**LAND USE DEVELOPMENT ROAD SAFETY AUDIT (THEMATIC)  
OF**

**PROPOSED RESIDENTIAL AGED CARE FACILITY**

**AT 11-15 LANG ROAD, 76-80 MARSH PARADE, 536-542 HUME HIGHWAY, CASULA**

**Document reference:** 18142.03FA

## ANNEXURE E: CONCEPT DRIVEWAY AND SITE LAYOUT PLAN

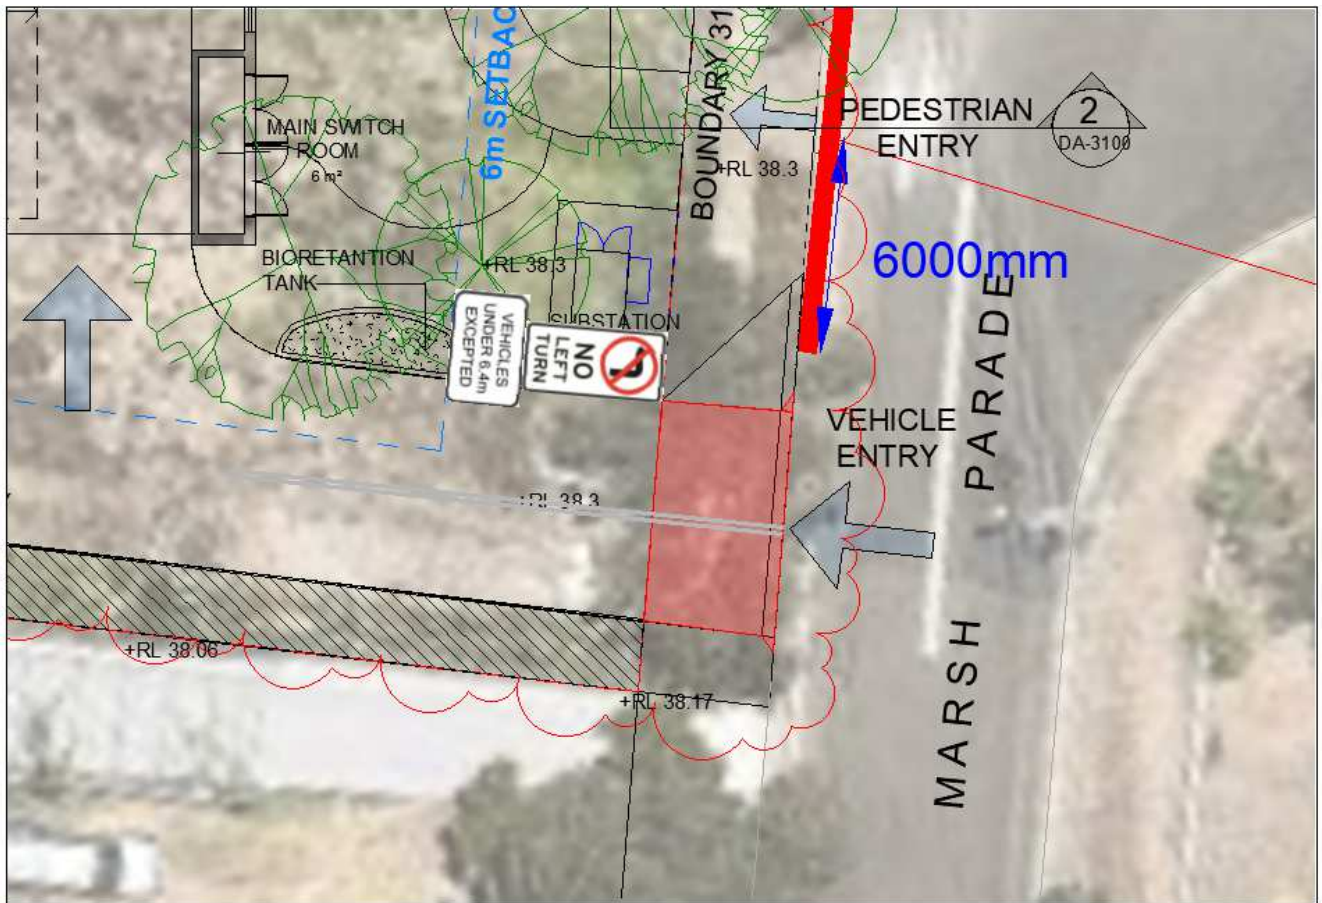
1. The proposed vehicular access (including proposed driveway splays) is located within prohibited driveway locations, with reference to *Clause 3.2.3 & Figure 3.1* of *AS2890.1-2004*. Refer to **Annexure D** for an illustration of non-compliant driveway locations.

Separation between egress and ingress vehicles should be considered to reduce the likelihood of conflict between entering and exiting vehicles. It is recommended that the site driveway be line marked down the centre with BB lines starting at the edge of the gutter to provide separation of entering and exiting vehicles, refer to **Annexure E** concept.

- (a) Modify / reduce the proposed driveway splay to accommodate left turn exit movements for vehicles up to a 6.4m SRV as per Clause 2.2 (a) of AS2890.2. The modification shall reduce the splay such that the driveway does not encroach into the prohibited driveway locations as per Clause 3.2.3 & Figure 3.1 of AS2890.1. It is expected that deliveries to the proposed development are occasional in nature, therefore service vehicles are capable of using the full width of the access driveway as per Clause 3.2.2 (d) of AS2890.2;

- (b) Install “NO LEFT TURN - VEHICLES UNDER 6.4m EXCEPTED” signage internally on the exit side of the site driveway;
    - (c) Implement a Plan of Management (PoM) for all deliveries by service vehicles to occur outside of peak arrival and departure times for visitors and staff;

- (d) A concept driveway and signage layout plan is shown in **Annexure E** for reference.
  2. Relocate site driveway to Lang Road
    - (a) Approximately 95m of road frontage suitable for an access driveway to be located;

Key:  Non-compliant driveway location  
 Concept driveway shaded red, splay for MRV left entry still requires detailing.

## ANNEXURE E: CONCEPT DRIVEWAY AND SITE LAYOUT PLAN

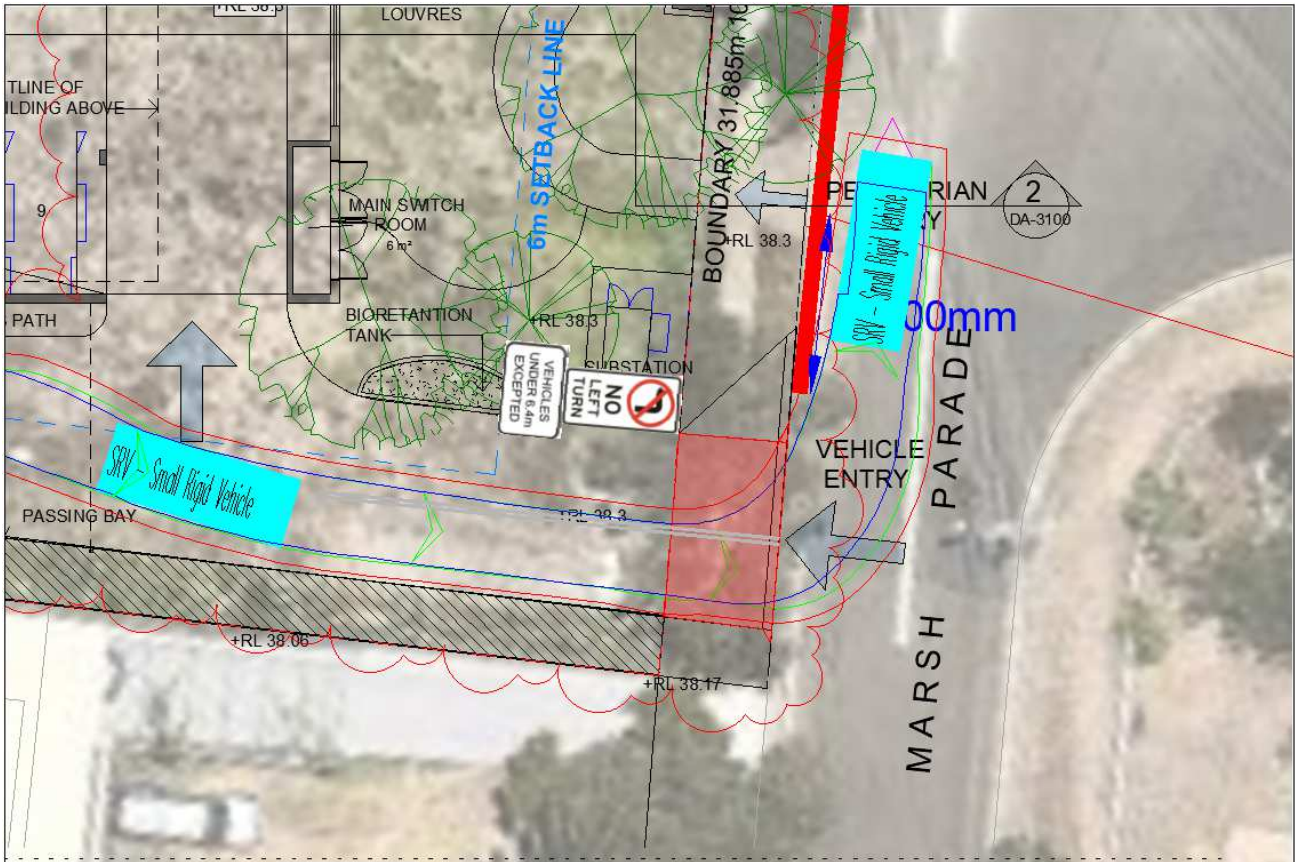
2. The swept path tests drawn by CBRK Pty Ltd dated 8 June 2018 show the MRV left turn onto Marsh Parade from the site driveway passes over the BB centre lines. An MRV passing over the centre line of the road has the potential to cause vehicle conflicts between the exiting vehicle and a vehicle traveling eastbound along Marsh Parade, resulting in potential side swipe or head on collisions.

**SRV LEFT turn from site driveway onto Marsh Parade**

**Tested @ 5km/h**

**Successful**
